PART 21 INVOLVING DEFECTIVE SPRING CLIPS USED AS SEISMIC RESTRAINTS ON TWO SCIENTIFIC MODULES

Subject: 10 CFR Part 21 Report Notification, CON2000 and RTD2100 Spring Clips

Subject: CON2000 & RTD2100 Spring Clips

Composite SBE Required Response Spectrum

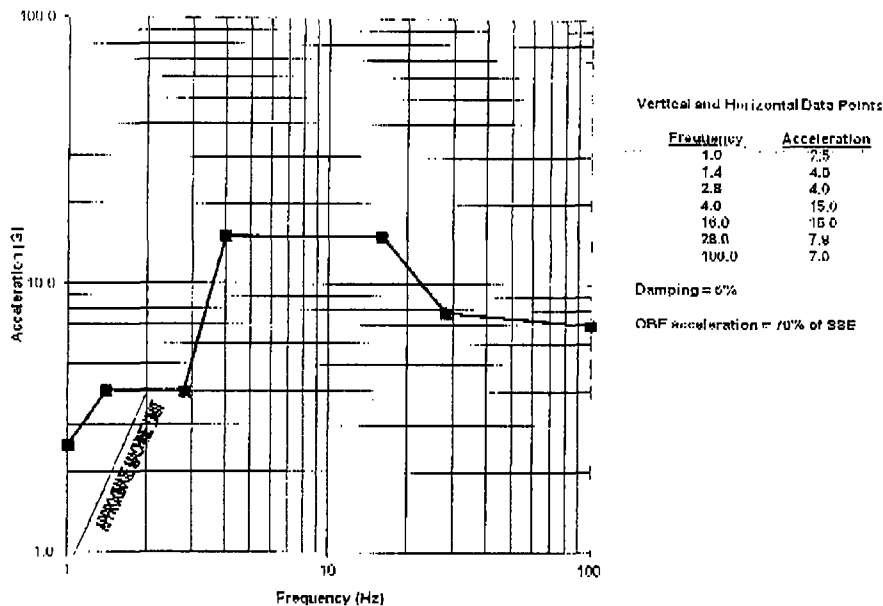
The module was seismically tested as documented in Qualification Report NUS-A056QA Rev 2. During the CON2000 test, a minor anomaly occurred and was accepted by Scientech as not affecting the qualification results. Recently a client questioned Scientech's acceptance of the anomaly and requested a retest. Scientech agreed to retest the module; the RRS used is attached. During the retest, the spring clip failed to adequately restrain the module.
